OHIO TURNPIKE AND
INFRASTRUCTURE COMMISSION

ADDENDUM NO. 2

PROJECT NO. 56-16-03
CASTALIA MAINTENANCE BUILDING
SITE IMPROVEMENTS
MILEPOST 106.70
ERIE COUNTY, OHIO

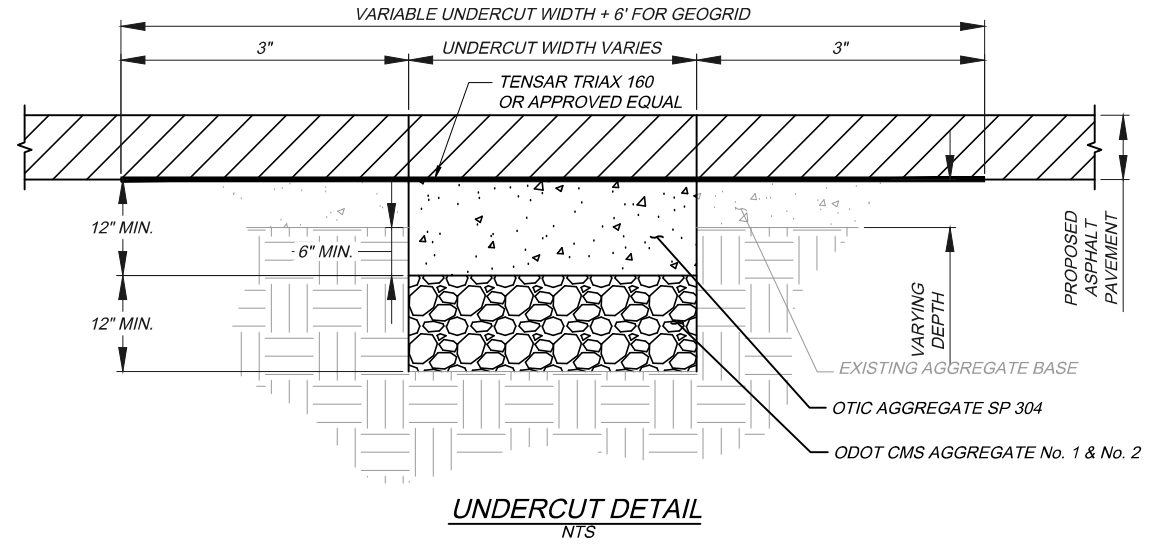
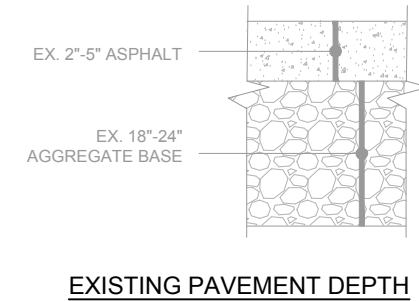
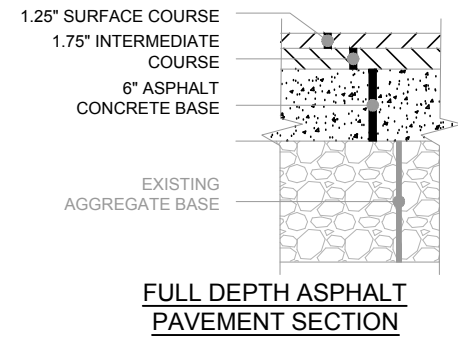
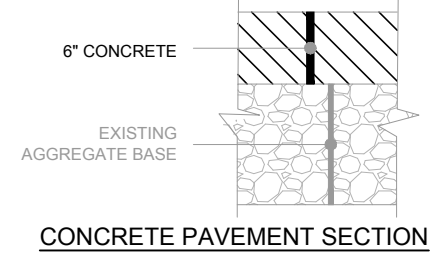
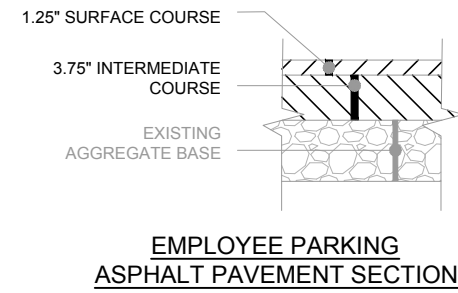
Q#2 There is a discrepancy between the unit of measure for the estimated quantity of Item No. 201 on the Bid Form (870 CU. YD.) and on Plan Sheet 2 of 6 under the General Note for Clearing Grubbing, Excavation and Embankment (870 SQ. YD). Please advise which unit of measure is correct.

Q#3 Has the engineer taken into account the 6” topsoil strip in the Excavation and embankment qty’s for the detention Basin?

Q#4 Where are we to put the costs for re-grading NW slope behind the Salt dome? Is there a qty of excavation for this work?

A#2 The unit of measure for Bid Item 201 – CLEARING & GRUBBING, AS PER PLAN is modified to a lump sum pay item. This Addendum No. 2 revises the General Note (Plan Sheet 2 of 6) to provide that clearing and grubbing is estimated to require an area of approximately 870 square yards at a depth of 6 inches, and that it is to be a lump sum pay item. Further, the Bid Item 201 – CLEARING & GRUBBING, AS PER PLAN referenced in the General Summary (Plan Sheet 3 of 6) and Estimated Quantities Worksheet (Excel spreadsheet) is revised to a lump sum quantity. The Bid Schedule of Items is similarly modified to reflect the lump sum method of payment for Ref. No. 2, Item No. 201 Clearing & Grubbing, As Per Plan.

A#3 Yes, to the extent that the approximately 150 Cu. Yds. (870 Sq. Yds. x 6 inches deep) of excavated topsoil is to be placed as topsoil over the constructed embankment for the Equalization Pond. Also, the General Notes state that an additional 5 Cu. Yds. Of topsoil will be required to bring the existing surface to final grade in the equalization pond area.

A#4 Based upon comparing the proposed grading plan to existing elevations in the area NW of the salt dome, the estimated quantities of excavation and embankment are provided in the General Notes. Additionally, as provided in the General Notes, “THE COST FOR ANY ONSITE EXCAVATION AND INSTALLATION OF SUITABLE EMBANKMENT MATERIAL GENERATED FROM THE SITE SHALL BE CONSIDERED INCIDENTAL TO THE PROJECT.” Therefore, the cost to move excavated material to areas onsite requiring embankment should be incorporated into with the selected bidder’s unit prices bid for Item 203 - EXCAVATION, AS PER PLAN.

REF.	ITEM	ITEM	APPROX.	
No.	No.	DESCRIPTION	QUANTITY	UNIT
1	IB. ART.6	PREMIUM FOR CONTRACT PERFORMANCE BOND AND PAYMENT BOND	1	LUMP
2	201	CLEARING & GRUBBING, AS PER PLAN	870 1	CU. YD. LUMP
